Description of document: Written or emailed complaints, criticism, or concern received at the National Capital Planning Commission (NCPC) concerning the Martin Luther King, Jr. National Memorial, 1999-2011

IN REPLY REFER TO:
NCPC File No. 5907

Thank you for the opportunity to participate in the review of the Environmental Assessment (EA) prepared for the Martin Luther King, Jr. National Memorial, on a site approved by the National Capital Planning Commission (NCPC) in December 1999.

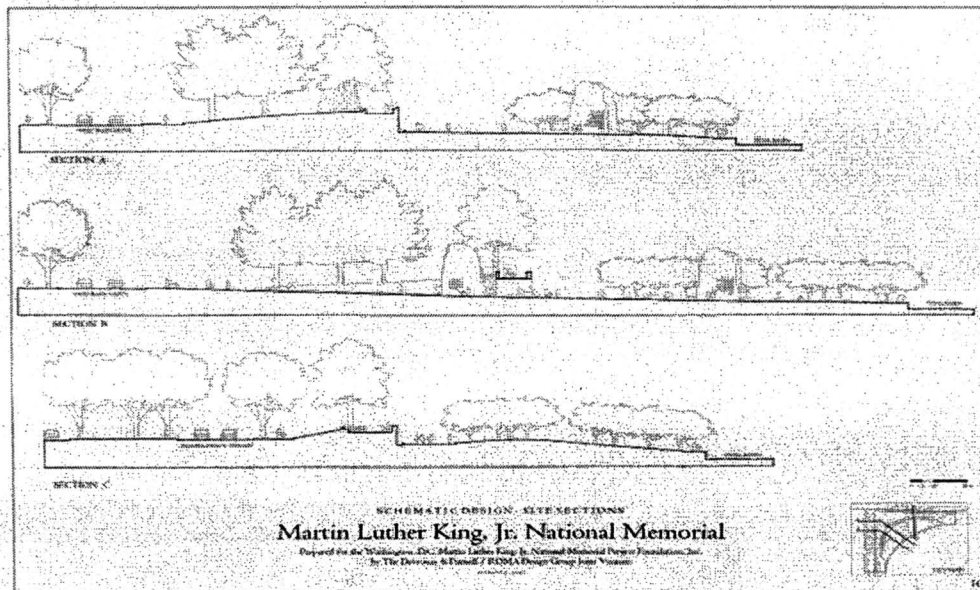
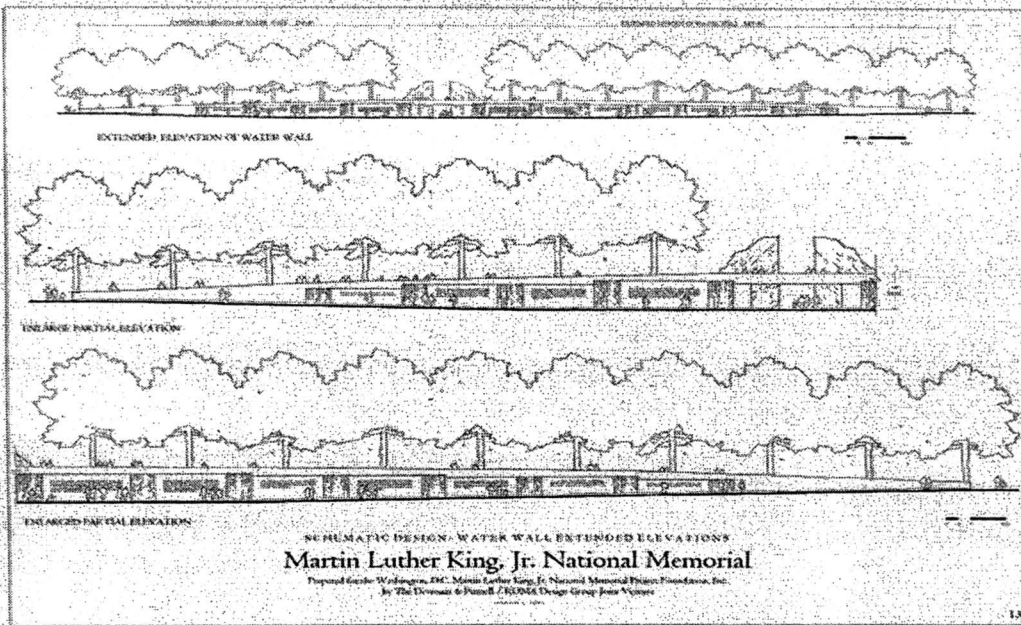
- As proposed, the bridge portion of the Memorial Walk adjacent to the Mountain of Despair has a major adverse impact on this signature element. The strength of the Mountain of Despair and Stone of Hope relationship is that the visitor should be able to clearly "see" that the Stone of Hope has emerged from the Mountain of Despair. The bridge element severely interrupts the dynamic visual tension that is intended to be created by these elements. Additionally, the horizontality of the bridge diminishes the necessary strong visual verticality of these stones. The bridge would also provide a place for visitors to stand above the primary important entrance to the memorial, thereby, further reducing the strong relationship between the Mountain of Despair and the Stone of Hope. NPS and the MLK Foundation should remove the bridge portion of the memorial walk.

- Redesign the entrance portal between the Mountain of Despair to remove the bridge of the Memorial Walk that interrupts views to the Stone of Hope and beyond, and to provide more space for visitor movement in this entry area.

DETAILS OF WATER FEATURES, BRIDGE, AND MEMORIAL WALK THAT WERE REMOVED FROM THE MEMORIAL CONCEPT DESIGN

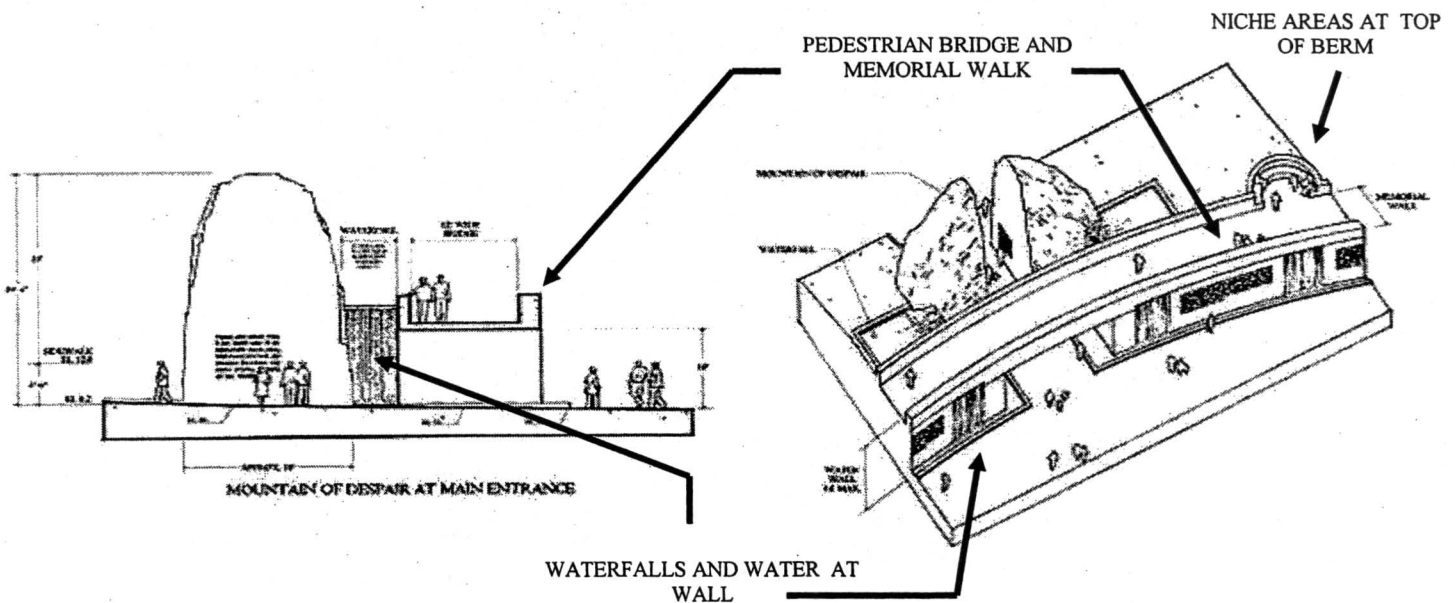
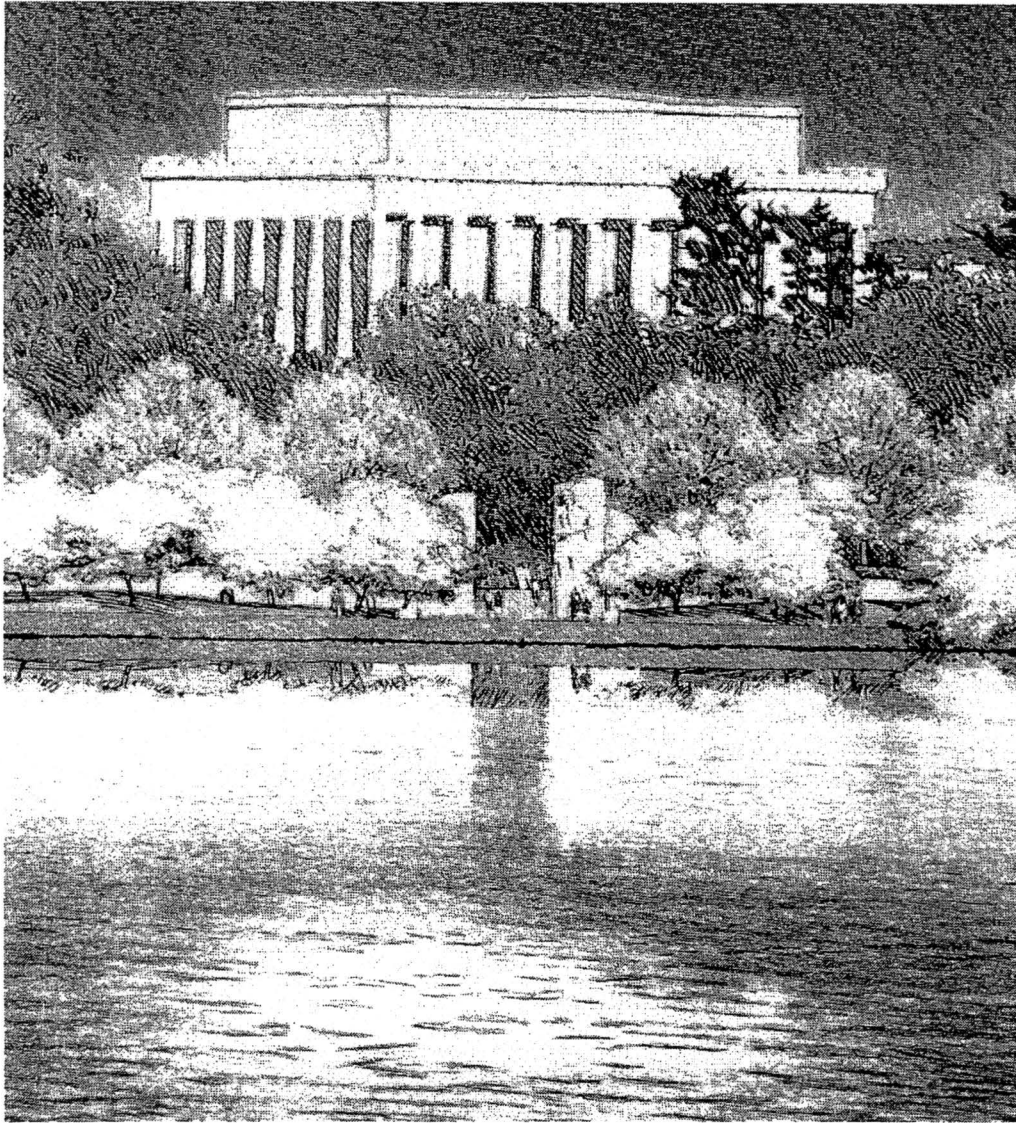
The revised concept removes three earlier features that the Commission had expressed concern about and where requested to be modified. These were:

- *Memorial Walk* – This element was elevated to a maximum height of 14 feet as it formed a bridge in front of the opening of the mountain of despair. It connected the two elevated niche areas and walk at the top of the berm.

FORECOURT SECTION AND DETAIL INDICATING BOLLARD LOCATION

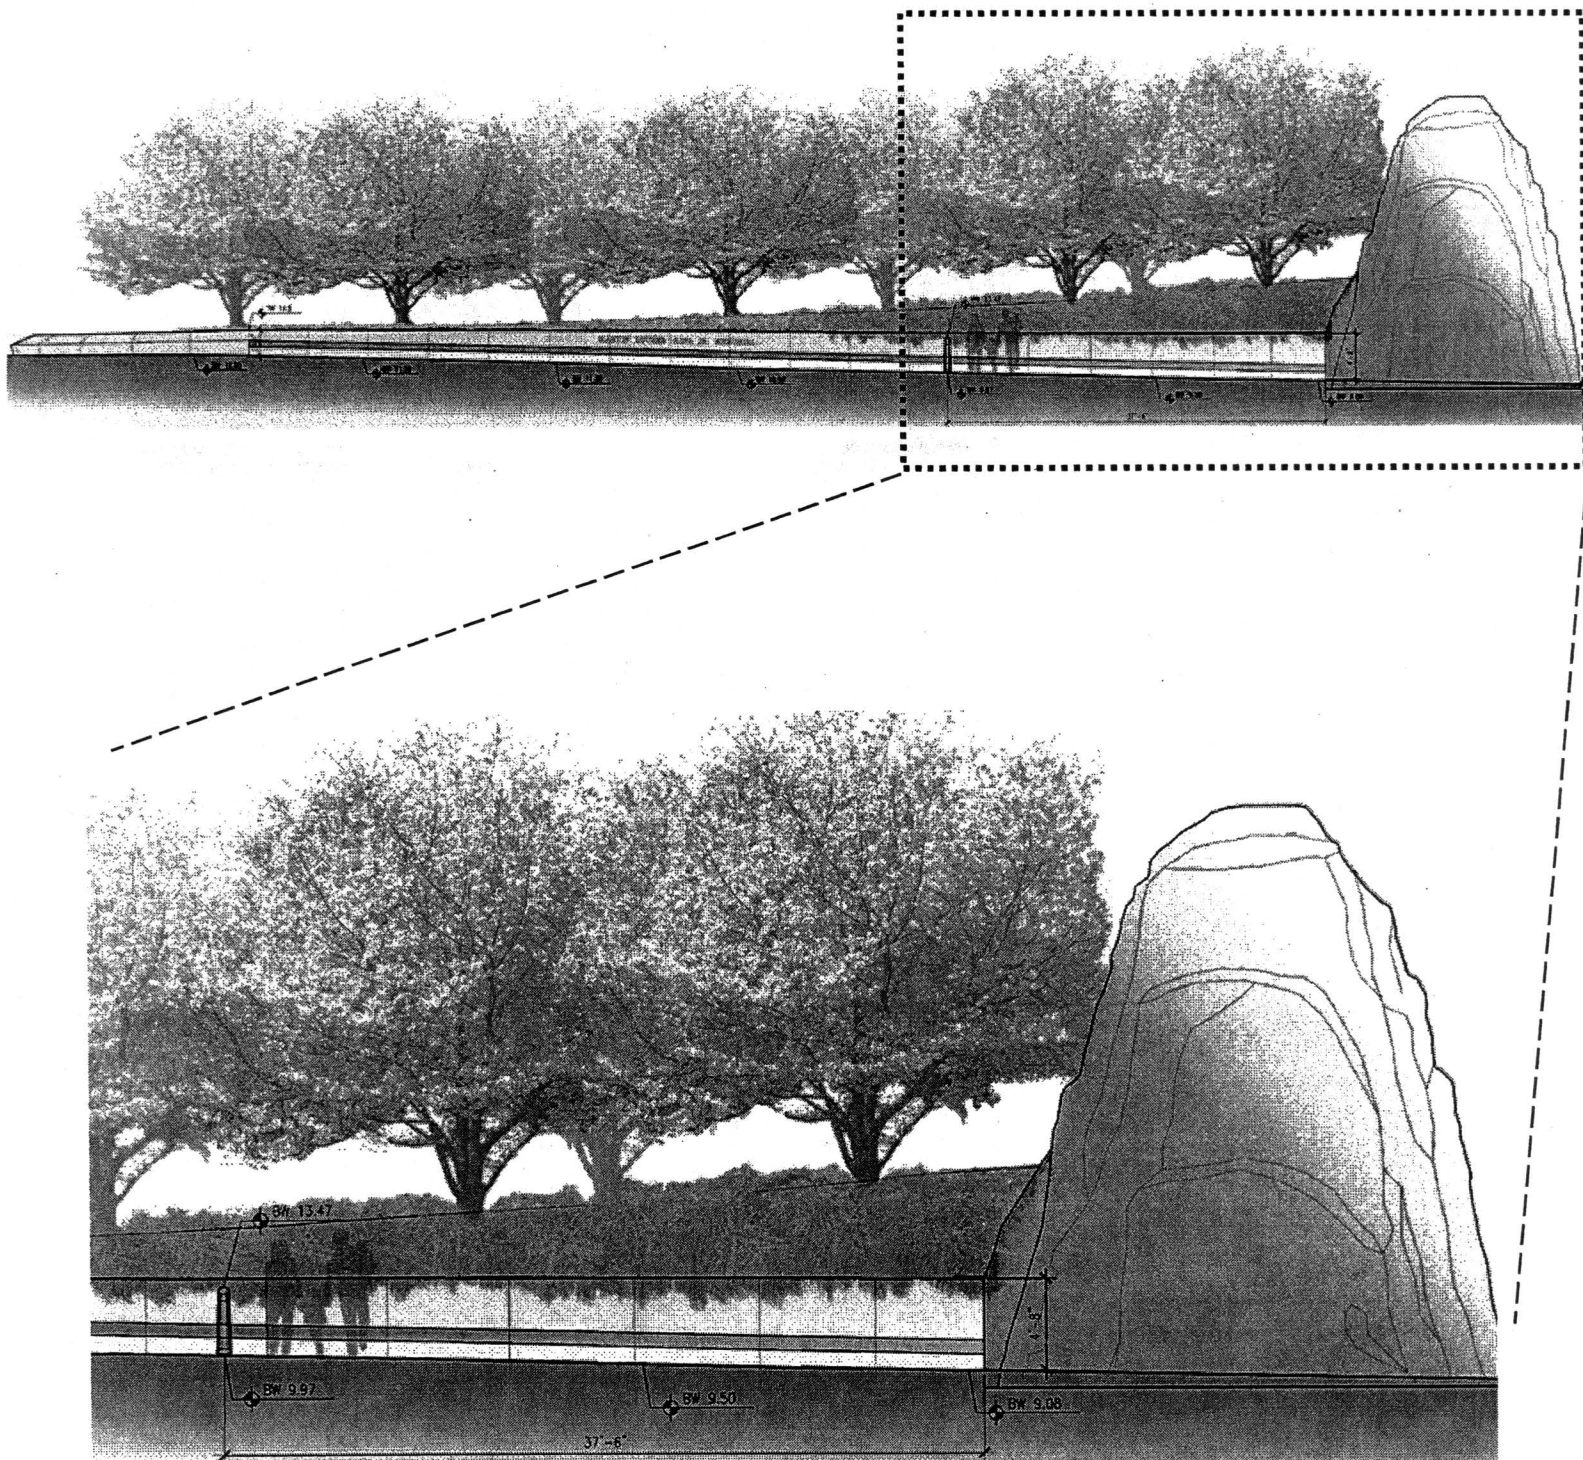
Additionally, staff is unconvinced that inclusion of bollards as shown on the drawings will fully address the security concerns outlined by the applicant. Given this and given the potential visual and physical intrusion that the bollards will have upon the Memorial; staff at this time cannot support the placement of bollards in the Memorial's forecourt or side entry walkways. Also, additional information on the potential visual and physical effects of the bollards would assist the Commission in its decision-making.

EARLY CLAY MODEL OF SCULPTURE WITH MODIFICATIONS NOTED ON ORIGINAL IMAGE OF DR. KING AT LEFT

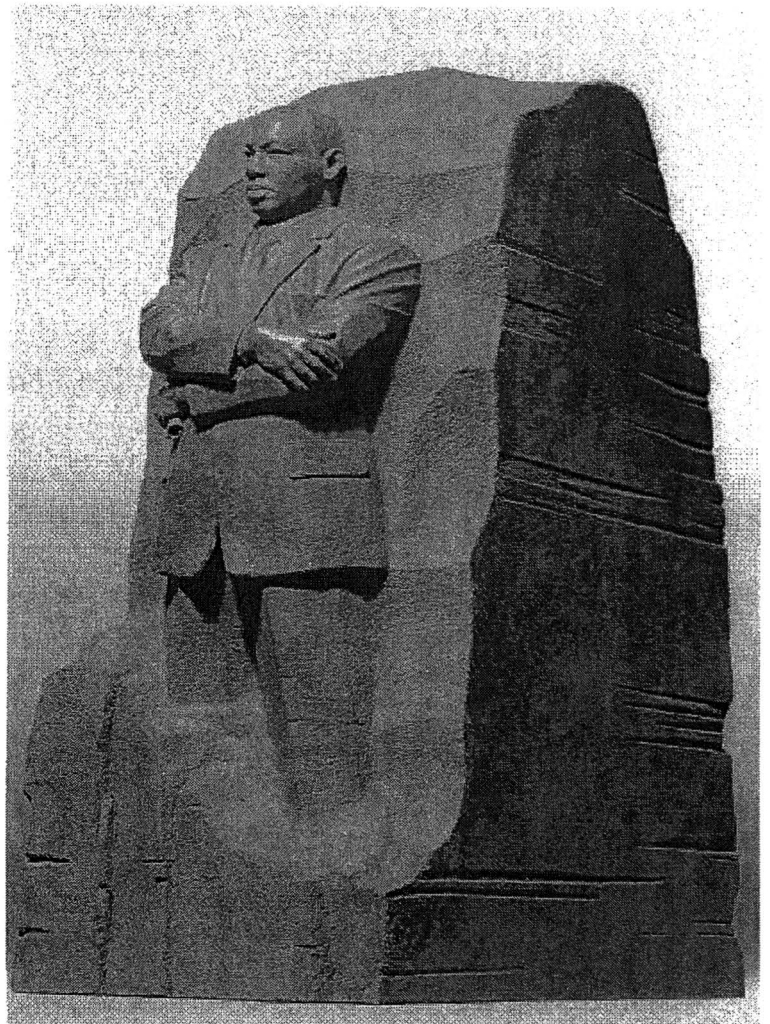
reduce the apparent amount of relief of the image thickness at its edges, and the base of the rough stone area has been elevated to just above the knee level of the figure on the left, as one views the figure. The sculpture also carries a rough stone appearance on the left and right side in the area of the suit-coat pocket. Finally, Dr. King's face has been somewhat altered to remove some facial-lines around the mouth and cheek area of the head. **Images of the sculpture are revised and submitted, as requested, for final approval. Staff recommends their approval.**
